Sektion 2. Utlandstillverkad flygmateriel

TITEL: Kontroll av slangar

Bulletin 003
August 1988

RECALL ON AEROQUIP 601 HOSE

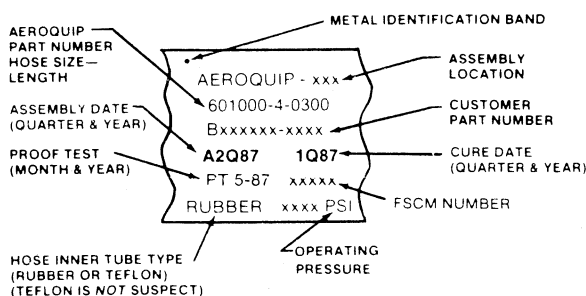
- Immediately inspect the aircraft for any Aeroquip hoses. Aeroquip-produced hose assemblies are identified with a metal identification band.

- Any Aeroquip 601 type hose assemblies that are identified with 1Q84 through 3Q87 hose cure date are suspect and should be removed. The cure dates may be shown CD1Q84 through CD3Q87.
- If the hose cure dates are not shown, then Aeroquip 601 type hose assemblies identified with an assembly date of A2Q84 through A2Q88 should be removed. If assembly date is shown in month and year, remove all assemblies with assembly date April 1984 through May 1988.
